Subject: Comments on MUN De-Designation Draft Staff Report

California Urban Water Agencies (CUWA) appreciates the opportunity to comment on the Draft Staff Report and Basin Plan Amendment to remove the Municipal and Domestic Supply (MUN) designation from 12 water bodies in the Sacramento Basin. CUWA's primary interest in this process is in protecting the MUN beneficial use and preventing degradation of water quality in downstream water bodies.

Figure 1. Total Aluminum Concentrations in the Colusa Basin Drain

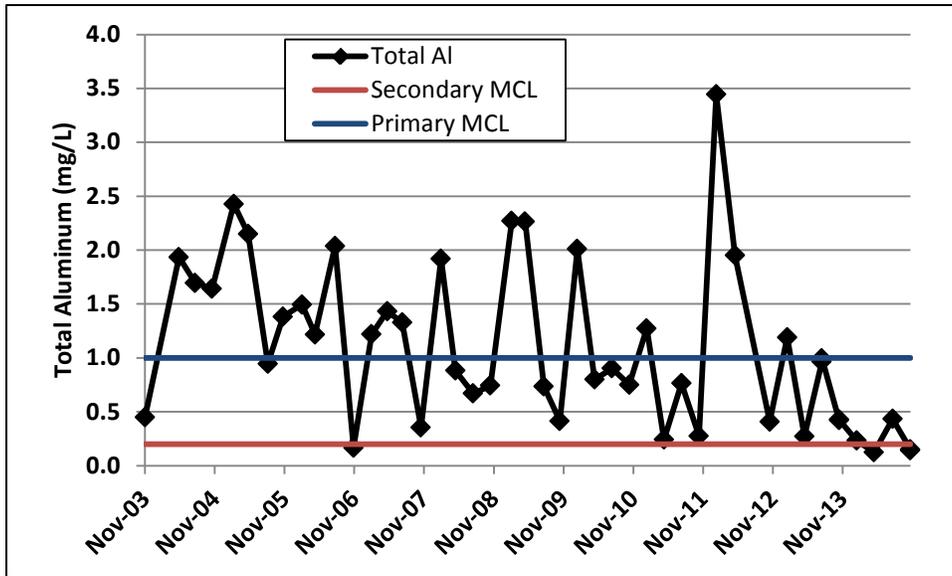
The Central Valley Water Board staff conducted monitoring on one day in June 2014 in the Colusa Basin Drain and Sutter Bypass and found that water quality objectives for several constituents (aluminum, iron, manganese, and sodium) were exceeded. CUWA conducted an analysis of aluminum and manganese concentrations near the mouth of the Colusa Basin Drain reported by the Department of Water Resources Municipal Water Quality Investigations (MWQI) Program. These data are shown in Figures 1 and 2 of Attachment 1. Aluminum concentrations exceeded the secondary maximum contaminant level (MCL) of 0.2 mg/L in most of the samples collected over a ten year

period and frequently exceeded the primary MCL of 1 mg/L. Manganese concentrations consistently exceeded the secondary MCL of 0.05 mg/L. These data indicate that the discharges from the Colusa Basin Drain and Sutter Bypass routinely do not meet the water quality objectives for aluminum and manganese.

The Central Valley Water Board staff should conduct this type of analysis for other drinking water constituents to establish the current conditions at the mouth of the Colusa Basin Drain and Sutter Bypass and in the Sacramento River immediately downstream of these two discharges. This analysis should be completed before the Central Valley Water Board considers the Basin Plan Amendment.
